WATER WELL RECORD (WWC5.2)

NIC: NMW-44DR Replacement Well Location; Former El Paso Refinery Site

Subject: Approval of Variance for Direct-Push Small Diameter Monitoring Wells. North Industrial Corridor (NIC) Site (KDHE Project Code C2-087-70150). Located in SE, Sec. 4, T. 27S, R.1E, Wichita, SG County, KS.

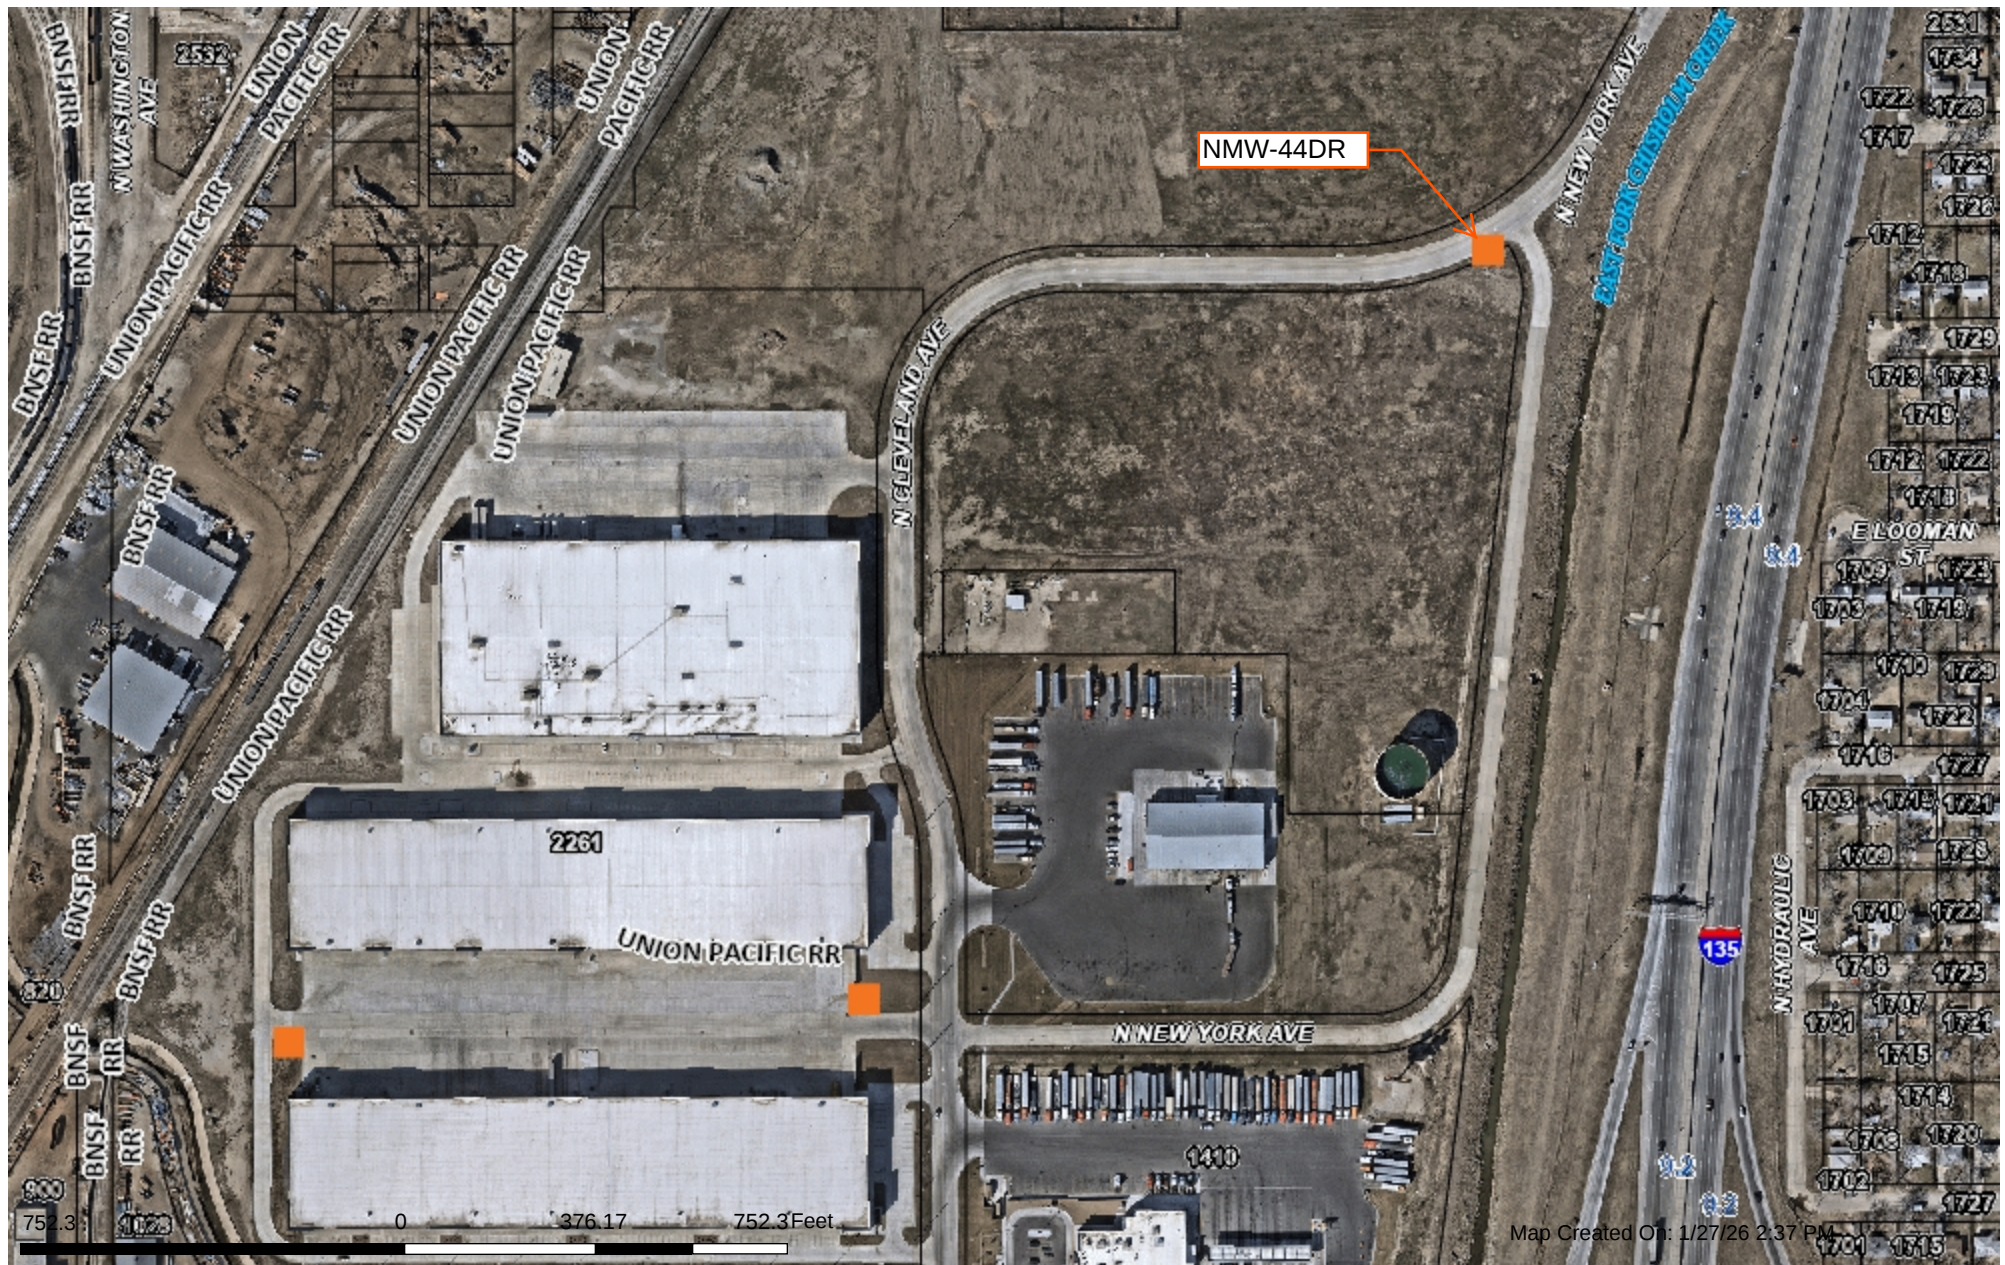
On May 4, 2026, the Kansas Department of Health & Environment, Bureau of Water, Geology & Well Technology Unit, Water Well Program (KDHE), received your variance request to construct three (3) flush-mount, small diameter monitoring wells using direct-push technology (DPT), at the above referenced area under contract with the City of Wichita. The request is to replace three (3) monitoring wells (NMWs 43DR2, 44DR, and 45DR) at the Former El Paso Refinery Site, all to be constructed with less than the required minimum annular space as per K.A.R. 28-30-6(b)(2).

KDHE considers the method of construction described in the request, and method of grouting as proposed in and approved for previous Below Ground Surface variance requests at this site to be adequate.

This letter provides notice of approval to construct three (3) small diameter monitoring wells within the subject area described above. Please comply with KDHE regulations in K.A.R. 28-30-6(s) for flush-mount well completion.
